ADDENDUM NO: 1

PROJECT: **SITE IMPROVEMENTS AT FRANKLIN CENTRAL JUNIOR HIGH**

CONTEXT PROJECT NO: 22-1613 DATE: 2/13/2024 BY: Fred Prazeau

Sheet No:
L103

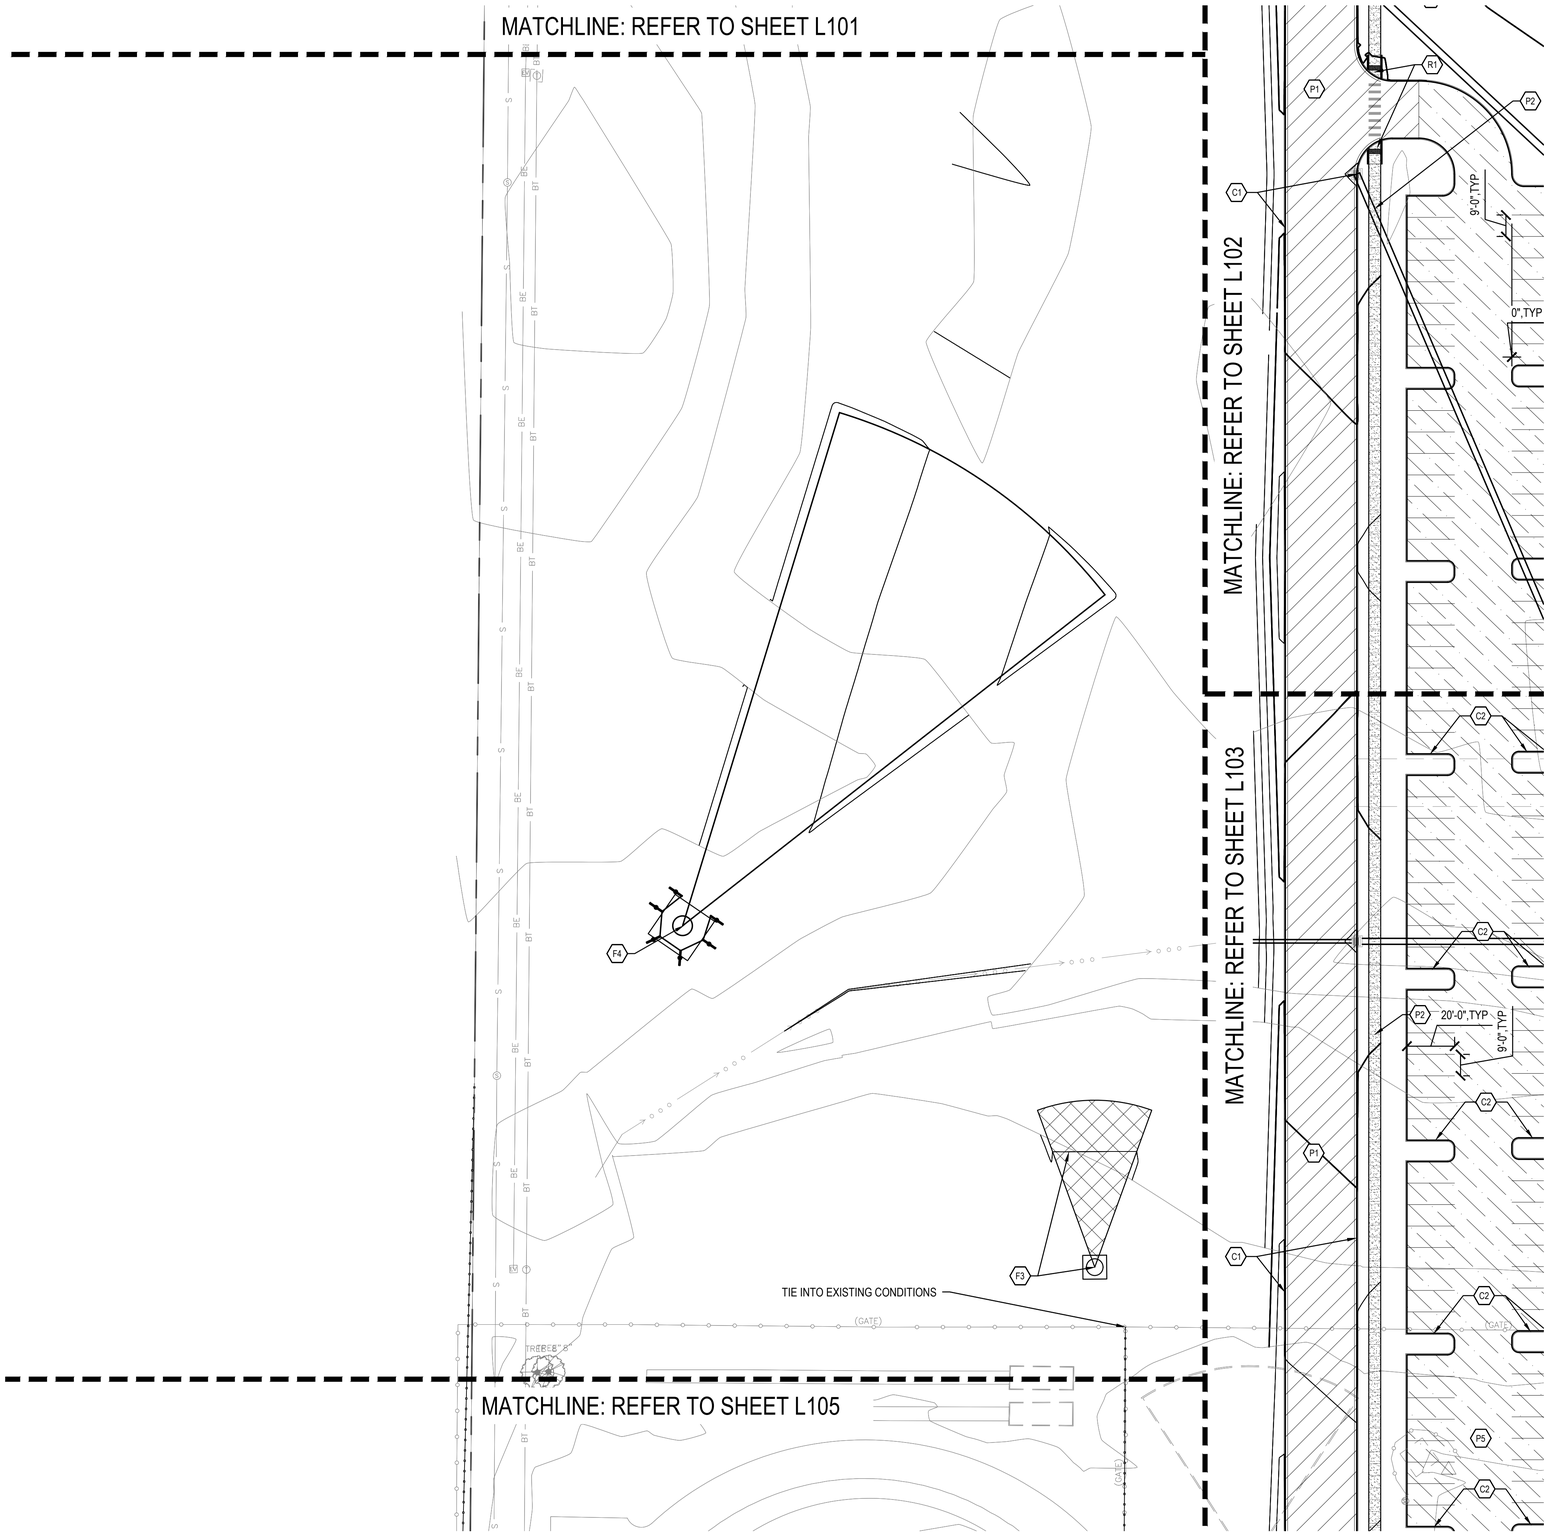
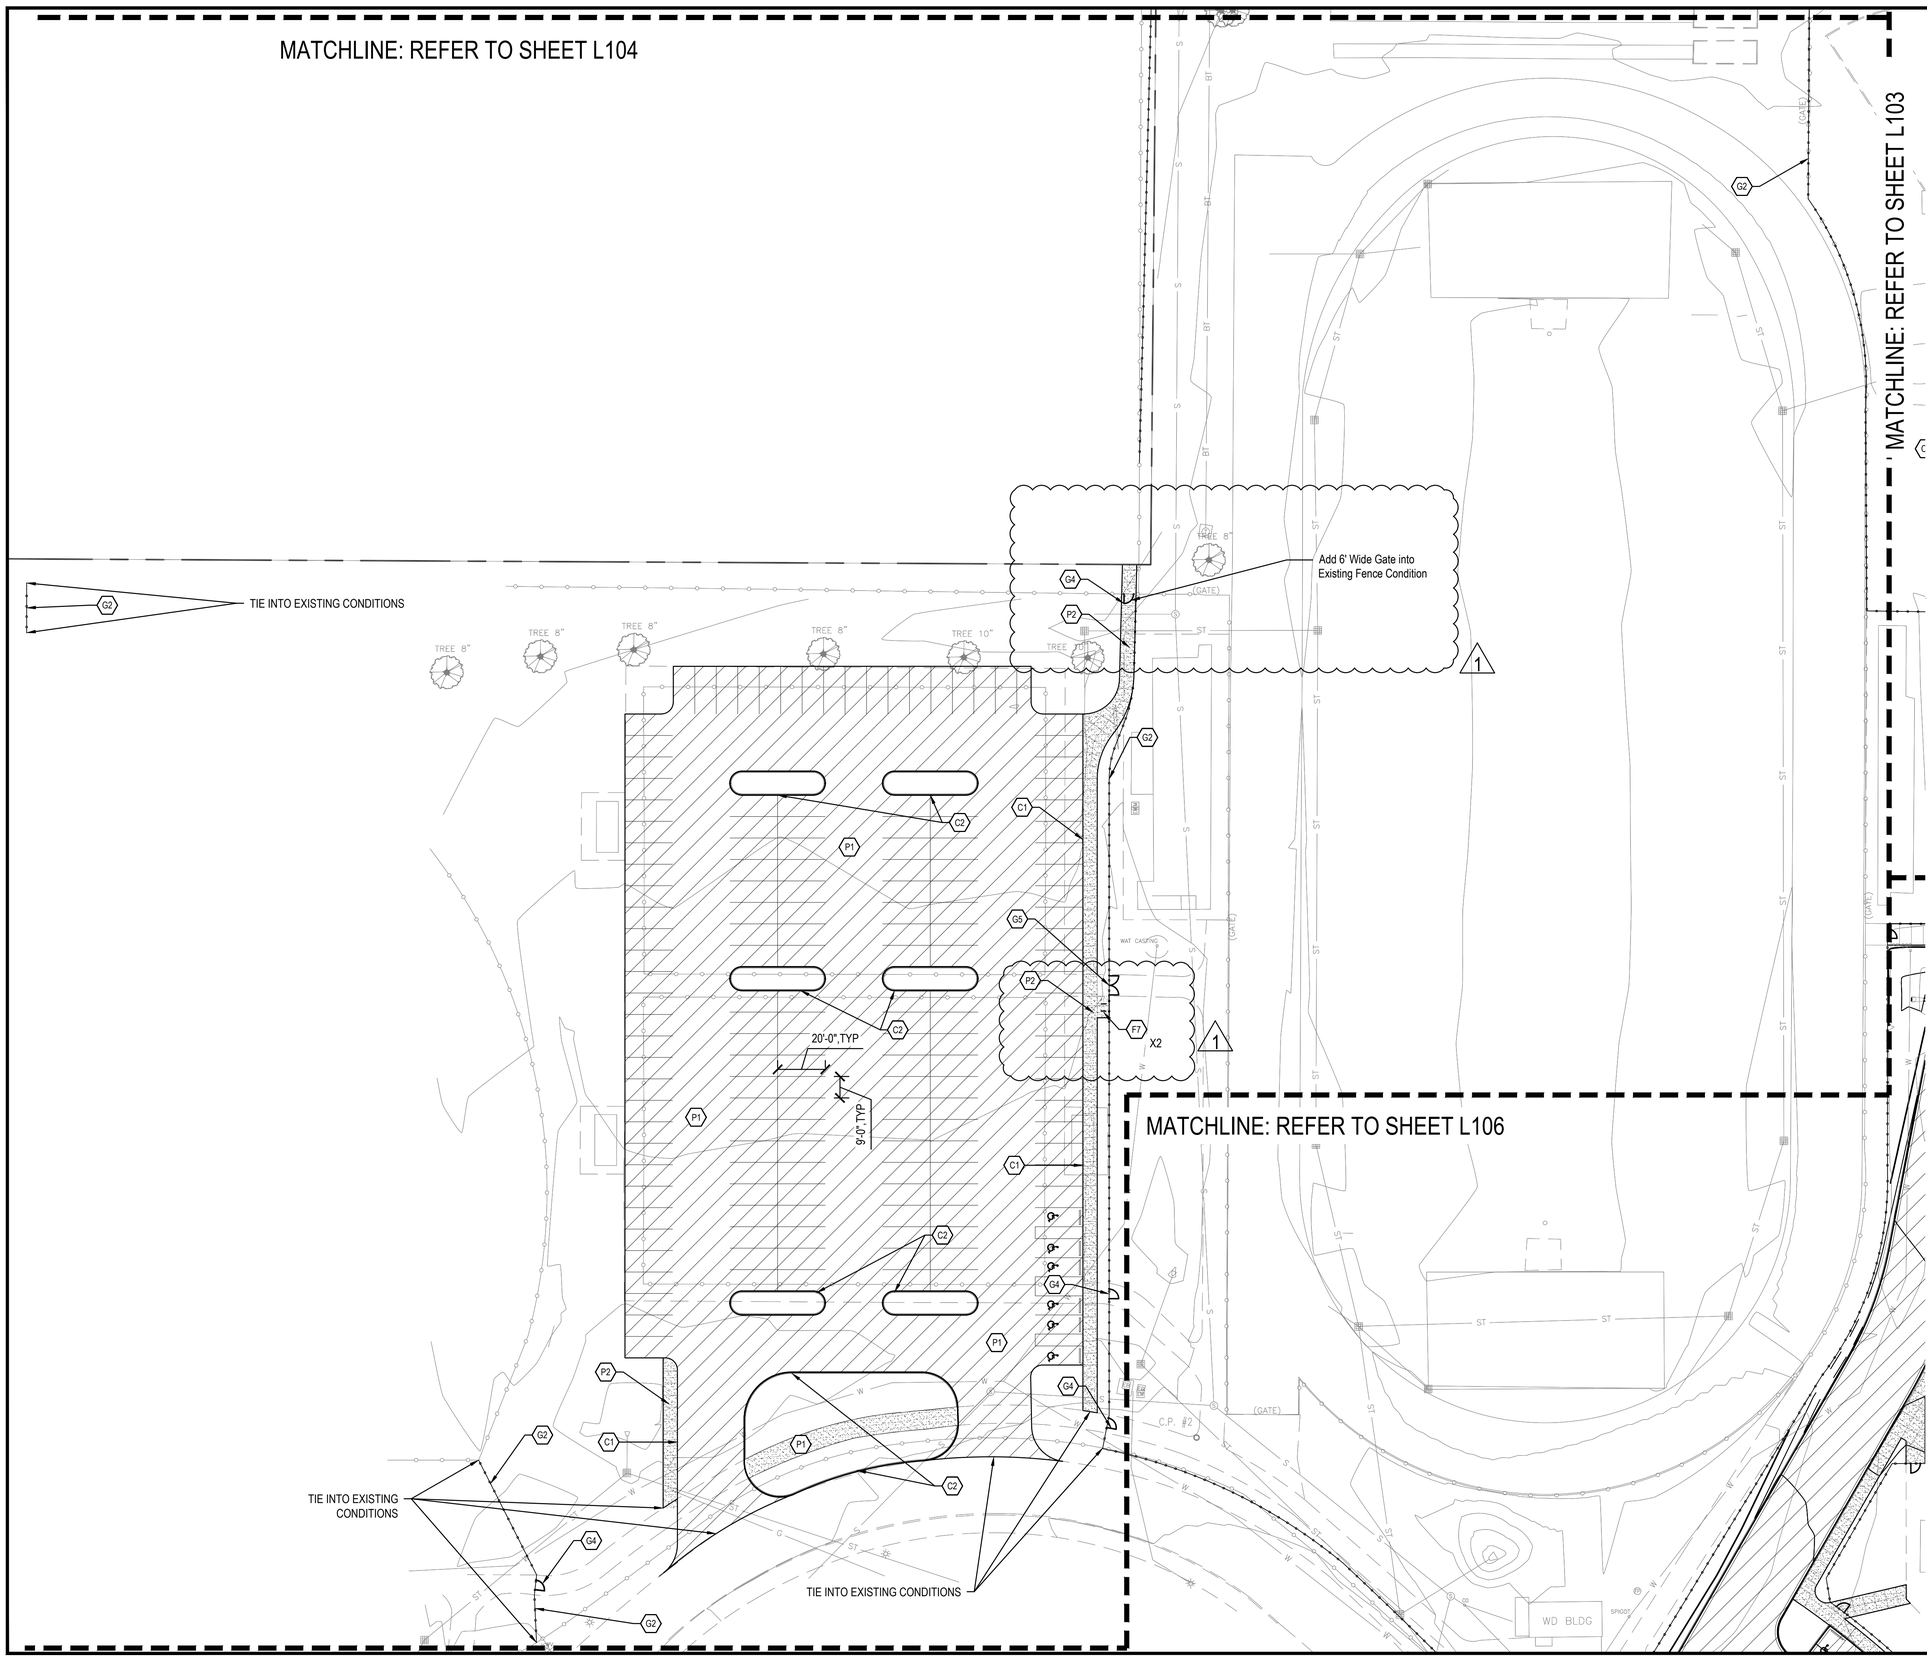
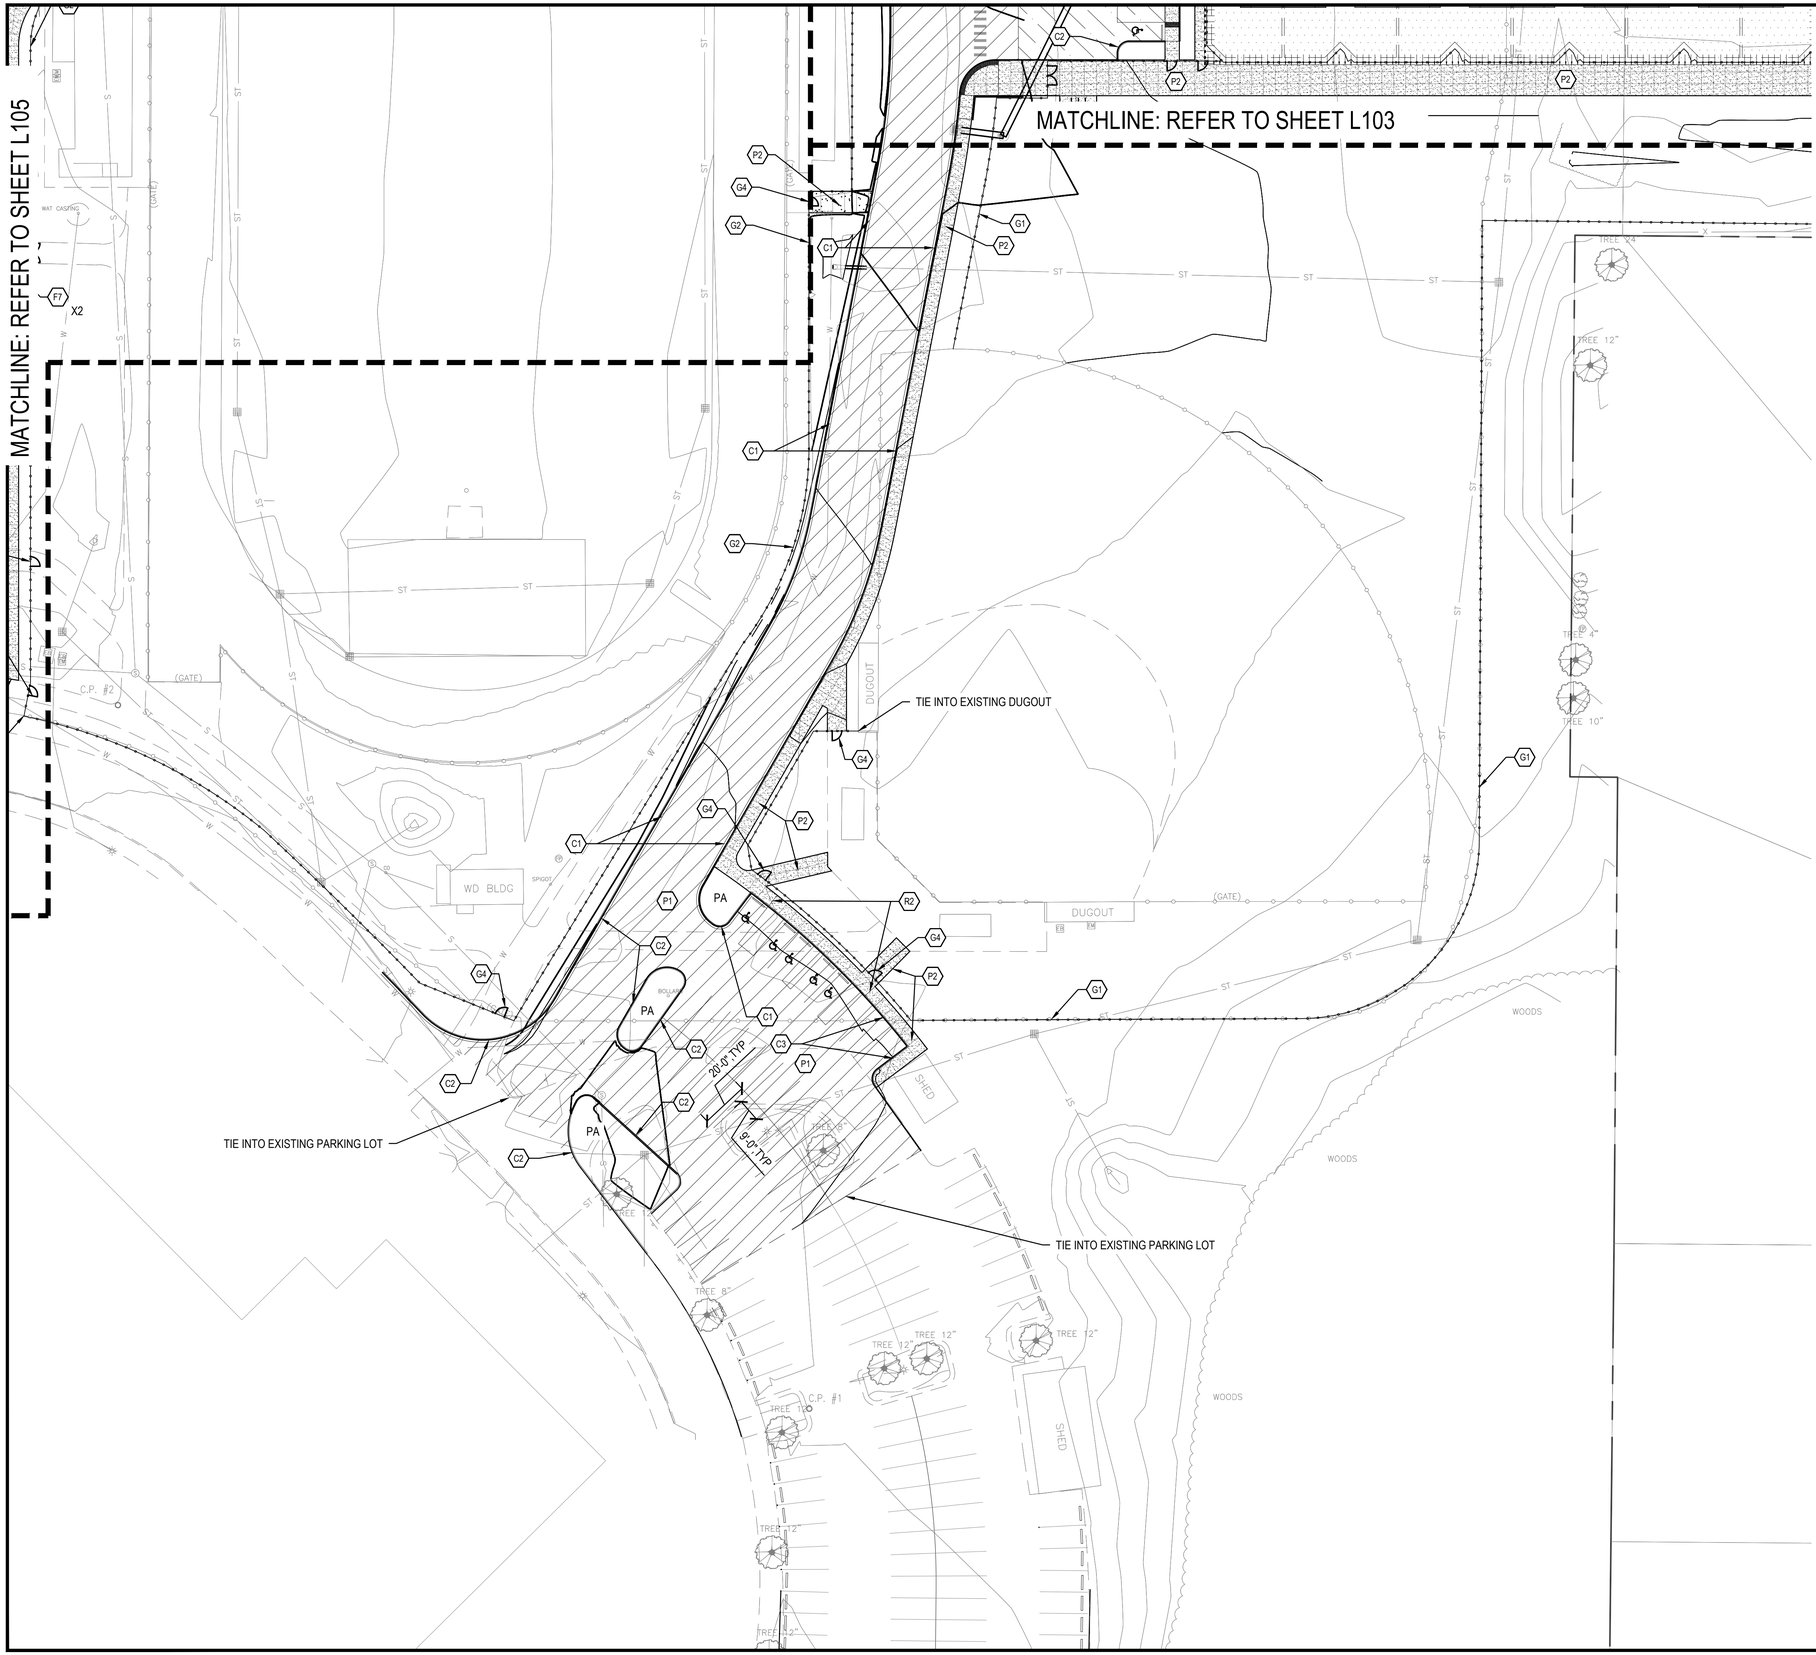
1. L100-Series Material Identification Plans reissued to address City comments, including clarifications to curb ramps, crosswalks, tree protection (single tree), soccer parking islands, and bike racks.
2. L300-Series Landscape Plans reissued to address City comments, including additional landscape planting, parking lot islands, and tree protection (single tree). Sheet L310 added.
